Re: In the Spirit of the Freedom of Information Act, Government Transparency and the Right to Know

# Pictures Documenting Some of My Concerns Related to the Protection of the ASPA Water Supply from Cross-Contamination

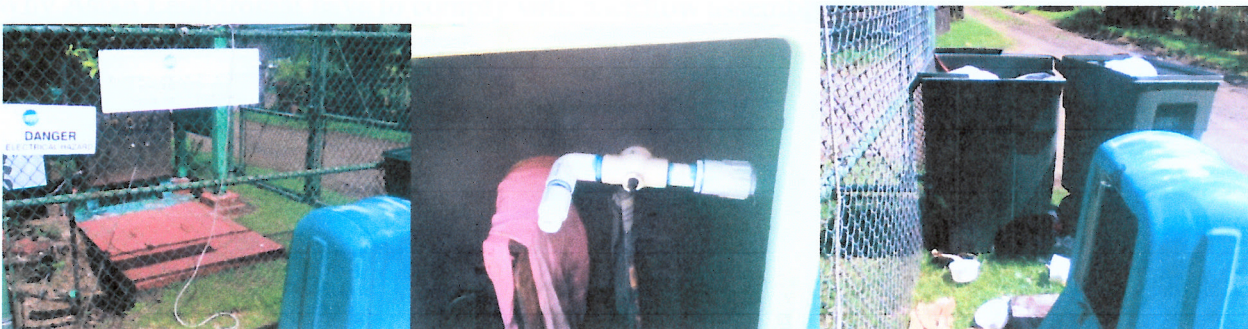
I think the ladder access to the LBJ Water Storage Tank should be Locked? Why not LBJ lock their ladder?

Typical ASPA Sewer Lift Station. Looks like it once had a Back Flow Assembly but it was removed WTF?
